UNITED STATES  
DEPARTMENT OF THE INTERIOR  
BUREAU OF LAND MANAGEMENTFORM APPROVED  
OMB NO. 1004-0135  
Expires: July 31, 2010**SUNDRY NOTICES AND REPORTS ON WELLS**  
*Do not use this form for proposals to drill or to re-enter an abandoned well. Use form 3160-3 (APD) for such proposals.*5. Lease Serial No.  
NMNM34850

MALACHITE 22 FEDERAL 2H

Devon Energy Production Company, L.P. respectfully requests approval to change the BOPE from 3M to a 3M system and add a multi-bowl wellhead system.

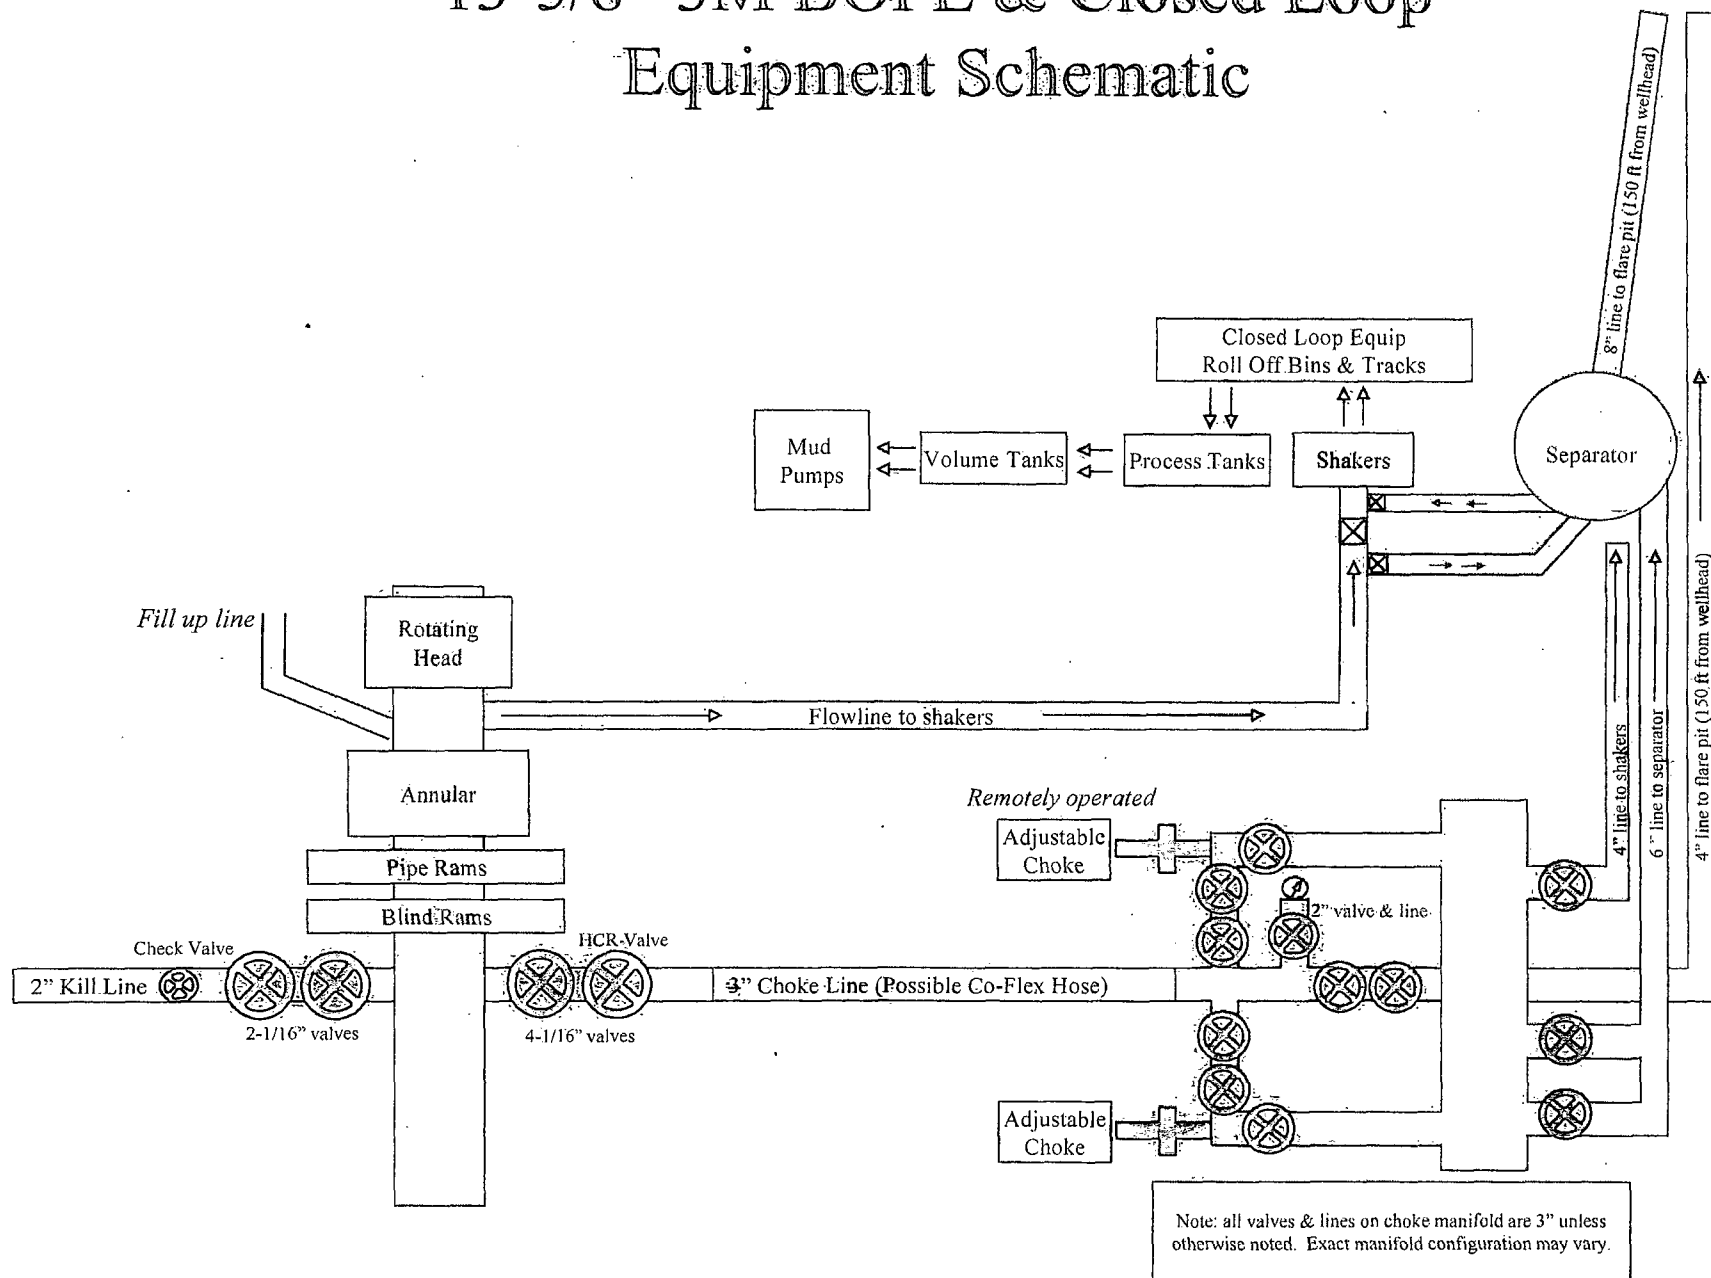
A multibowl wellhead is being used. The BOP will be tested per Onshore Order #2 after installation on the surface casing which will cover testing requirements for a maximum of 30 days. If any seal subject to test pressure is broken the system must be tested.

- Wellhead will be installed by FMC's representatives.
- If the welding is performed by a third party, the FMC's representative will monitor the temperature to verify that it does not exceed the maximum temperature of the seal.

- FMC representative will install the test plug for the initial BOP test.
- FMC will install a solid steel body pack-off to completely isolate the lower head after cementing intermediate casing. After installation of the pack-off, the pack-off and the lower flange will be tested to 5M, as shown on the attached schematic. Everything above the pack-off will not have been altered whatsoever from the initial nipple up. Therefore the BOP components will not be retested at that time.

- If the cement does not circulate and one inch operations would have been possible with a standard wellhead, the well head will be cut and top out operations will be conducted.

- Devon will pressure test all seals above and below the mandrel (but still above the casing) to full working pressure rating.
- Devon will test the casing to 70% of burst or 1500 psi, whichever is greater, as per Onshore Order #2.

2. Operator has proposed a multi-bowl wellhead assembly. This assembly will only be tested when installed on the surface casing. Minimum working pressure of the blowout preventer (BOP) and related equipment (BOPE) required for drilling below the surface casing shoe shall be 3000 (3M) psi.

- a. Wellhead shall be installed by manufacturer's representatives, submit documentation with subsequent sundry.
  - b. If the welding is performed by a third party, the manufacturer's representative shall monitor the temperature to verify that it does not exceed the maximum temperature of the seal.

- c. Manufacturer representative shall install the test plug for the initial BOP test.
  - d. Operator shall perform the intermediate casing integrity test to 70% of the casing burst. This will test the multi-bowl seals.

- e. If the cement does not circulate and one inch operations would have been possible with a standard wellhead, the well head shall be cut off, cementing operations performed and another wellhead installed.

# 13-5/8" 3M BOPE & Closed Loop Equipment Schematic

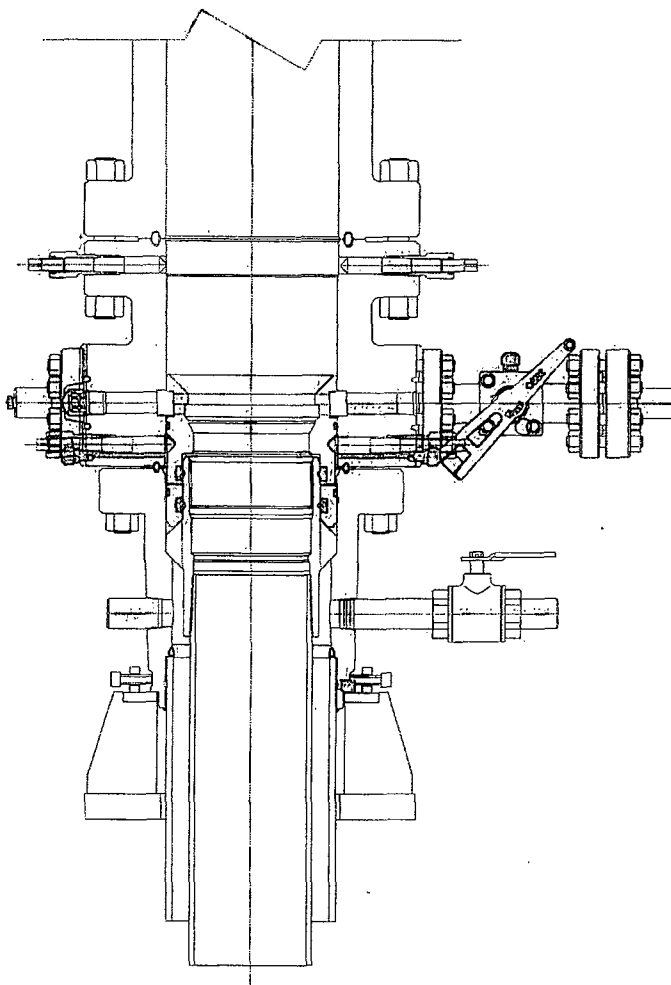
After running the 13-3/8" surface casing, a 13-5/8" BOP/BOPE system with a minimum rating of 3M will be installed on the FMC Uni-head wellhead system and will undergo a 250 psi low pressure test followed by a 3,000 psi high pressure test. The 3,000 psi high and 250 psi low test will cover testing requirements a maximum of 30 days, as per Onshore Order #2. If the well is not complete within 30 days of this BOP test, another full BOP test will be conducted, as per Onshore Order #2.

After running the 9-5/8' intermediate casing with a mandrel hanger, the 13-5/8" BOP/BOPE system with a minimum rating of 3M will already be installed on the FMC Uni-head.

The pipe rams will be operated and checked each 24 hour period and each time the drill pipe is out of the hole. These tests will be logged in the daily driller's log. A 2" kill line and 3" choke line will be incorporated into the drilling spool below the ram BOP. In addition to the rams and annular preventer, additional BOP accessories include a kelly cock, floor safety valve, choke lines, and choke manifold rated at 3,000 psi WP.

See attached schematic.
